**PLANNING APPROVAL &
PLANNED UNIT DEVELOPMENT
STAFF REPORT**

Date: February 21, 2008

<u>NAME</u>	Archbishop of Mobile, McGill-Toolen High School
<u>DEVELOPMENT NAME</u>	Archbishop of Mobile, McGill-Toolen High School
<u>LOCATION</u>	3610 Michael Boulevard (Northeast corner of Michael Boulevard and Marion Beckham Drive)
<u>CITY COUNCIL DISTRICT</u>	District 5
<u>PRESENT ZONING</u>	R-1, Single-Family Residential
<u>AREA OF PROPERTY</u>	1 lot / 20.4± Acres
<u>CONTEMPLATED USE</u>	Planning Approval to amend a previously approved Planning Approval to allow the expansion of an existing private school athletic complex in an R-1, Single-Family Residential District to include additional stadium seating, a field house, concession stand and additional parking, Planned Unit Development Approval to amend a previously approved Planned Unit Development to allow the expansion of an existing stadium complex with multiple buildings on a single building site.
<u>TIME SCHEDULE FOR DEVELOPMENT</u>	Immediate

SITE PLAN

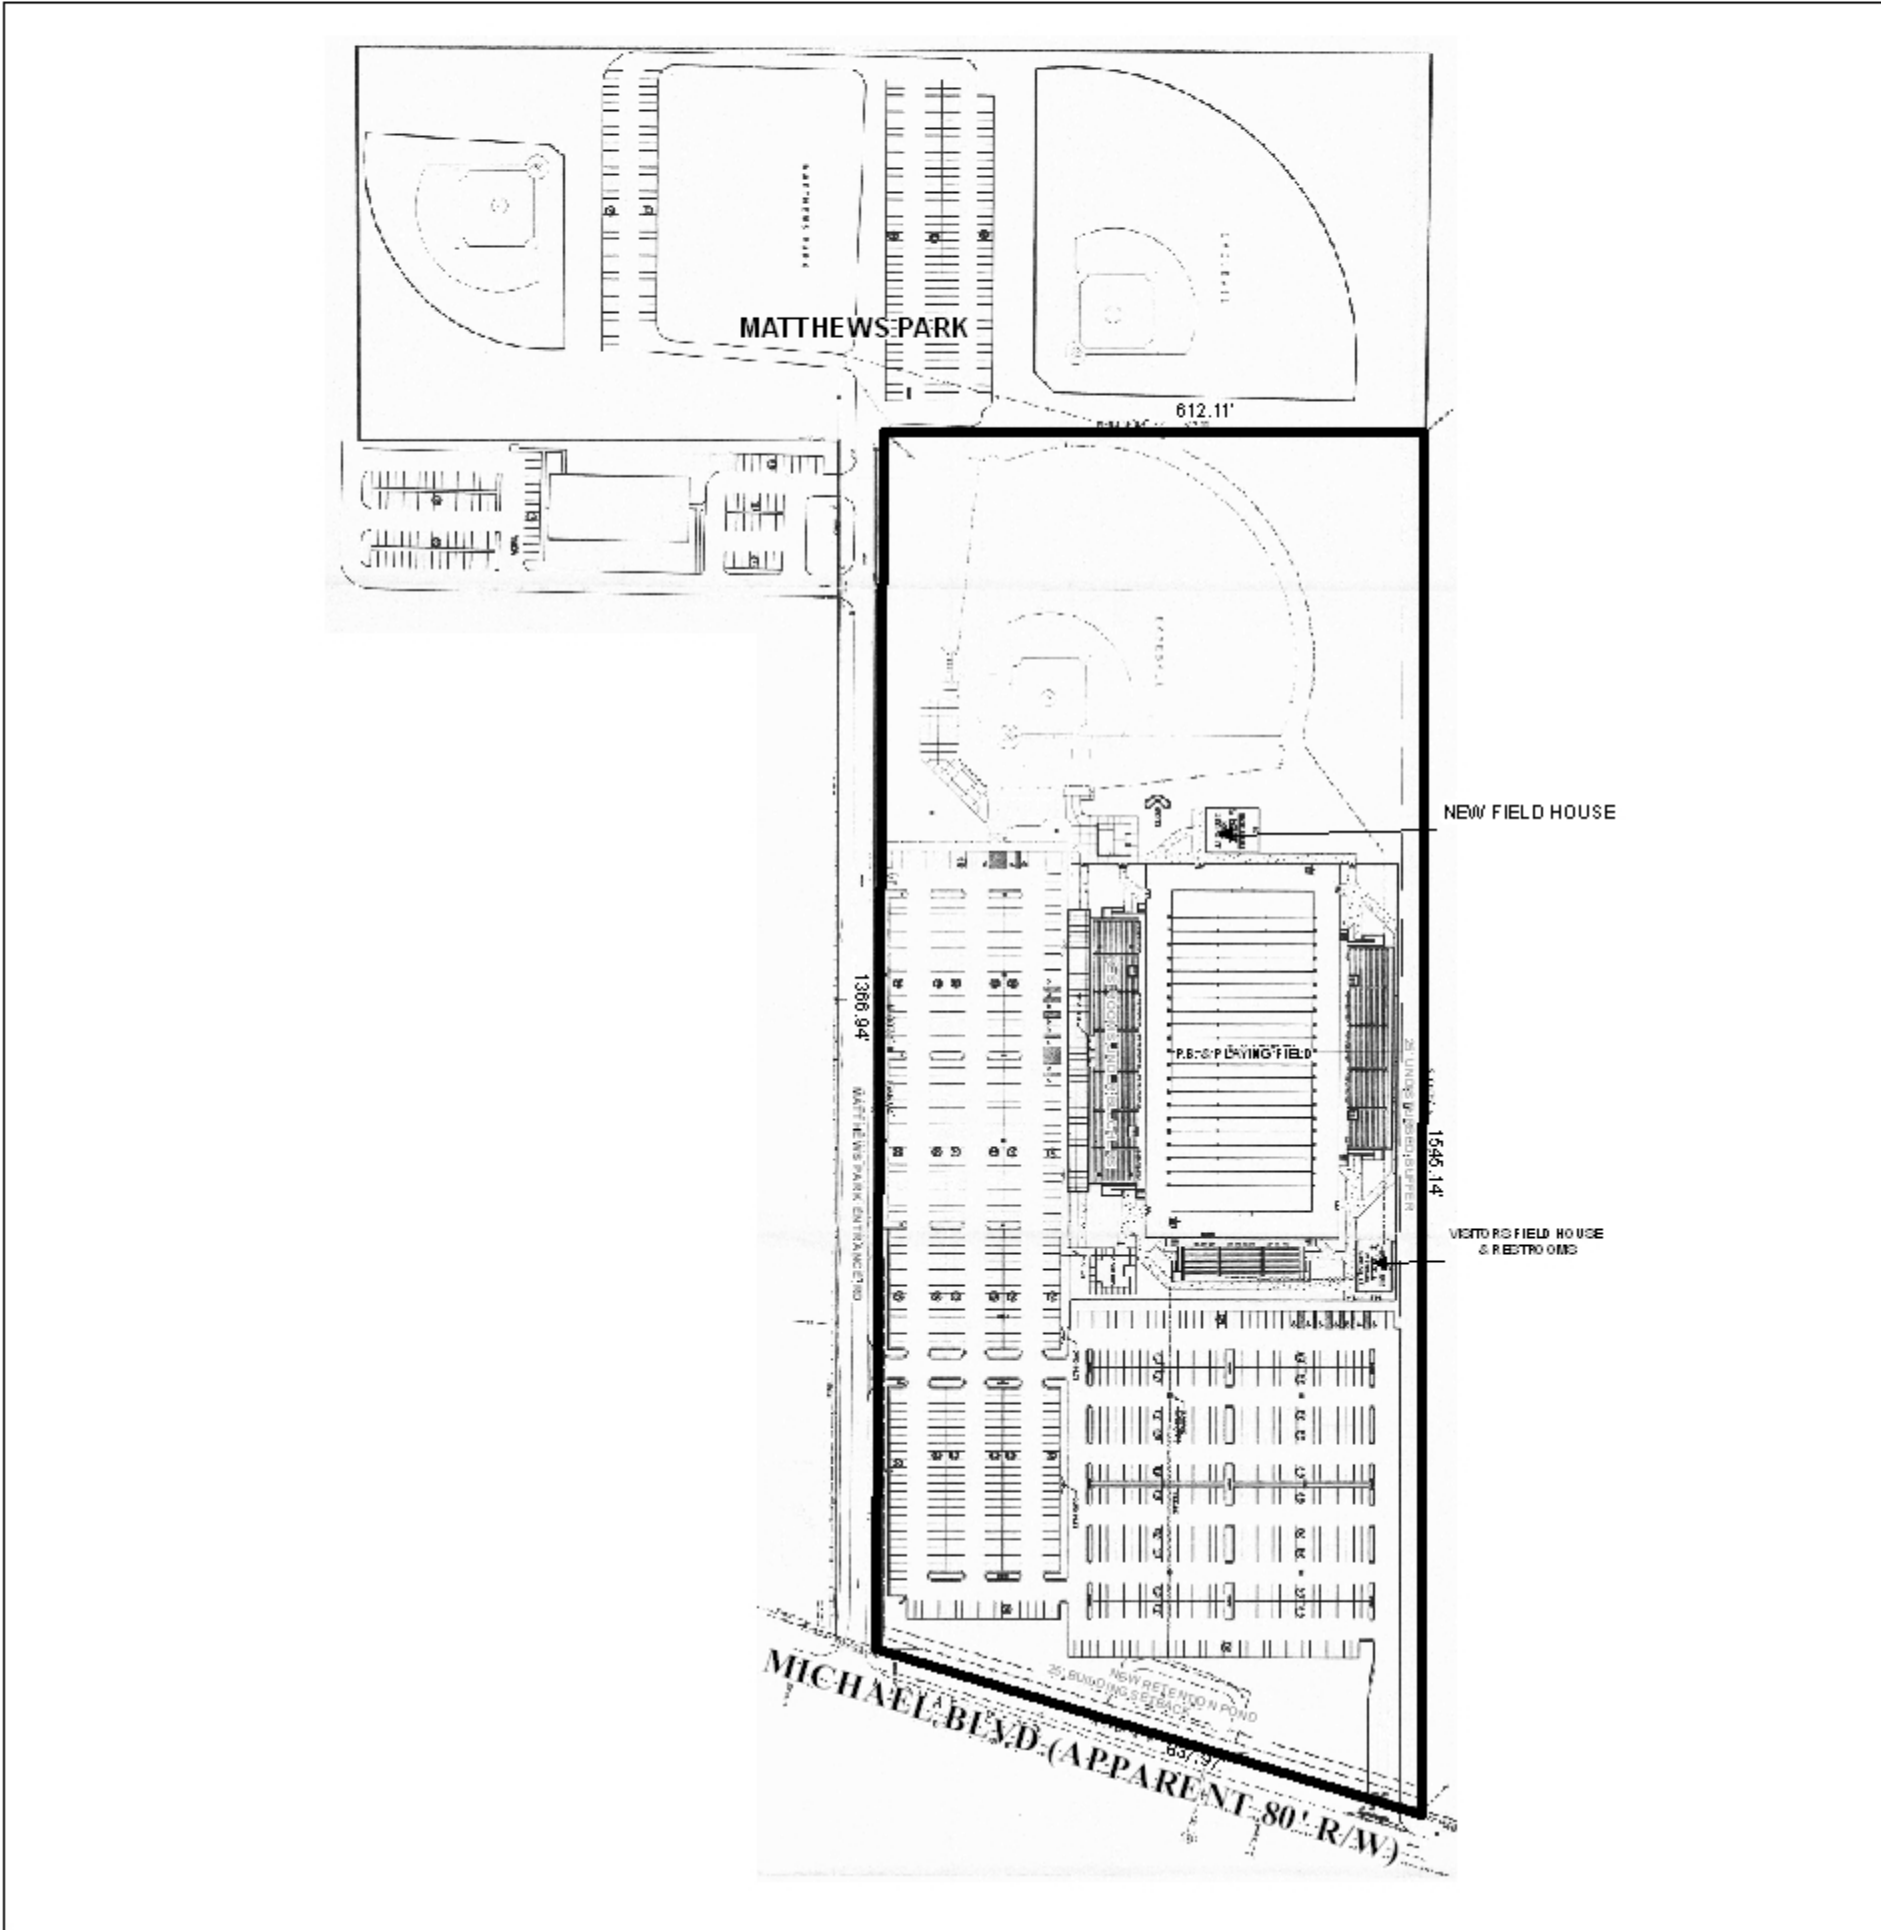
The site plan depicts the existing and new paved parking area layout that will change with the proposed construction of the complex. The existing parking layout allows traffic to circulate

across the site, to and from Marion Beckham Drive, which maximizes parking on site. However, with the substantial addition to the complex, and the increased parking to provide the required number of spaces for the stadium, the curb-cut to Michael Boulevard would increase traffic flow to and from the site.

The overall site plan illustrates on-site parking space availability of 896 spaces, which exceeds the spaces required by the Zoning Ordinance for a 3,386 seat stadium is (based on one space per four seats - 847 spaces). However, the inclusion of the parking areas of Matthews Park and the YMCA increases the available parking spaces by 335.

The site plan also shows the provision landscaping, trees and buffering (25-foot undisturbed) where the site abuts residential uses.

The site plan shows sidewalks within the site; however, sidewalks are not illustrated along Marion Beckham Drive and Michael Boulevard. Therefore, the development should also be required sidewalks along both road frontages to provide pedestrian access to all of the proposed parking areas of the Planned Unit Development (PUD).

Section 64-6. of the Zoning Ordinance requires that lighting be provided for off-street parking facilities containing more than ten spaces, if the parking facilities will be used after dark. If lighting of the building or parking area is proposed, the lighting must fully comply with Sections 64-4.A.2. and 64-6.A.3.c. of the Zoning Ordinance; specifically, lighting for the site should be designed and placed so that it does not shine onto residential properties (use of “full cut-off” fixtures).

Finally, there is no indication on the site plan as to the proposed location of any dumpster or other waste storage facility. If the applicant utilizes a dumpster, the location of the storage area for the dumpster must be indicated on the site plan, and the location and required screening must comply with Section 64-4.D.9. of the Zoning Ordinance, as well as with all other applicable regulations.

- 1) the construction be limited to the submitted and approved site plan;
- 2) the provision landscaping, trees and buffering (25-foot undisturbed) where the site abuts residential uses;
- 3) revision of the site plan to depict sidewalks all road frontages;
- 4) revision of the site plan to depict any dumpster storage facility, in compliance with Section 64-4.D.9. of the Zoning Ordinance;
- 5) placement of a note on the site plan stating that on-site lighting must fully comply with Sections 64-4.A.2. and 64-6.A.3.c. of the Zoning Ordinance;

- 6) provision of a revised Planning Approval site plan to the Planning Section of Urban Development prior to the signing of the final subdivision plat;
- 7) a letter from the owner's of Matthews Park and the YMCA allowing for overflow parking on their sites;
- 8) completion of the Subdivision process;
- 9) full compliance with all other municipal codes and ordinances; and
- 10) the submission and approval of a Traffic Impact Study as required by Traffic Engineering.

- 3) revision of the site plan to depict sidewalks all road frontages;
- 4) revision of the site plan to depict any dumpster storage facility, in compliance with Section 64-4.D.9. of the Zoning Ordinance;

- 5) placement of a note on the site plan stating that on-site lighting must fully comply with Sections 64-4.A.2. and 64-6.A.3.c. of the Zoning Ordinance;

- 6) provision of a revised PUD site plan to the Planning Section of Urban Development prior to the signing of the final subdivision plat;
- 7) a letter from the owner's of Matthews Park and the YMCA allowing for overflow parking on their sites;
